CITY PLAN COMMISSION

FILE NUMBER: PLAT-25-000079 (S245-228) SENIOR PLANNER: Hema Sharma

LOCATION: Buckner Boulevard, south of Jennie Lee Lane

REQUEST: An application to create one 0.819-acre lot from a tract of land in City Block E/6184 on property located on Buckner Boulevard, south of Jennie Lee Lane.

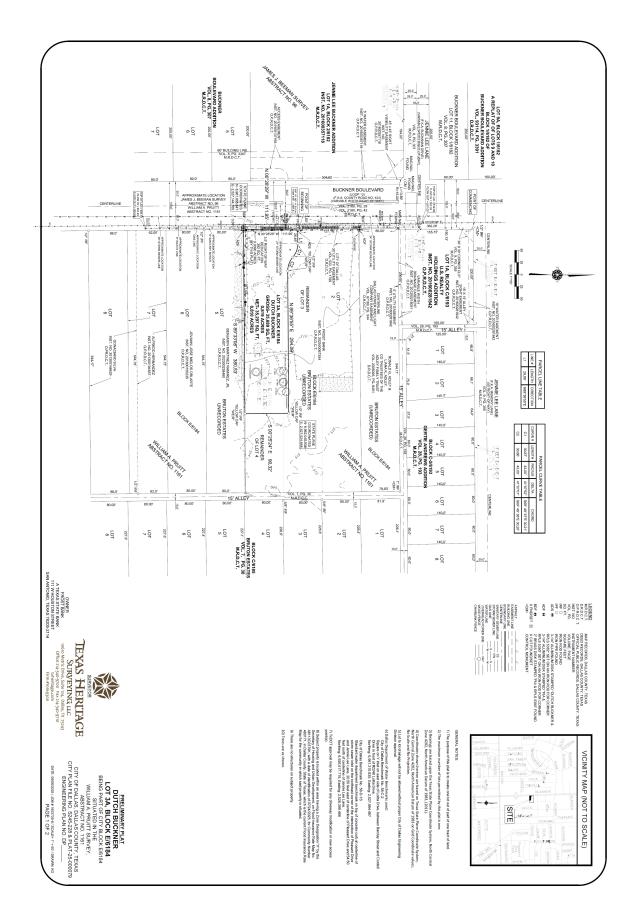
- 3. Compliance with all plans, contracts, ordinances, and requirements of the City of Dallas. Section 51A-8.102(a), (b), (c), and (d)
- 4. The number and location of fire hydrants must comply with the Dallas Fire Code.

- 5. Any new or existing structure may not extend across new property lines. Section 51A-8.503(e)
- 6. On the final plat, all easement abandonments, and ROW abandonments must be by separate instrument with the recording information shown on the face of the

- plat. A release from the Real Estate Division is required prior to the plat being submitted to the Chairman for signature.
- 7. On the final plat, include two boundary corners tagged with these coordinates: "Texas State Plane Coordinate System, North Central Zone, North American Datum of 1983 on Grid Coordinate values, No Scale and no Projection."

- 8. On the final plat, monument all set corners per the Monumentation Ordinance. Prior to submittal of the final plat for the Chairman's signature. The monuments must be verified by the Chief City Surveyors Office in the Public Works Department. Section 51A-8.617

- 15. On the final plat, dedicate 53.5 feet of right-of-way (via fee simple) from the established center line of Buckner Boulevard. *Section 51A 8.602(c)*
- 16. On the final plat, add the note: "TxDOT approval may be required for any driveway modification or new access point(s)." No citation.

- 19. Prior to final plat, submit a completed final plat checklist and all supporting documents.
- 20. On the final plat, show how all adjoining right-of-way was created. Section 51A-8.403(a)(1)(A)(xxii).
- 21. On the final plat, show distances/width across all adjoining right-of-way
- 22. On the final plat, show recording information on all existing easements within 150 feet of the property.

24. On the final plat, identify the property as Lot 3A in City Block E/6184.
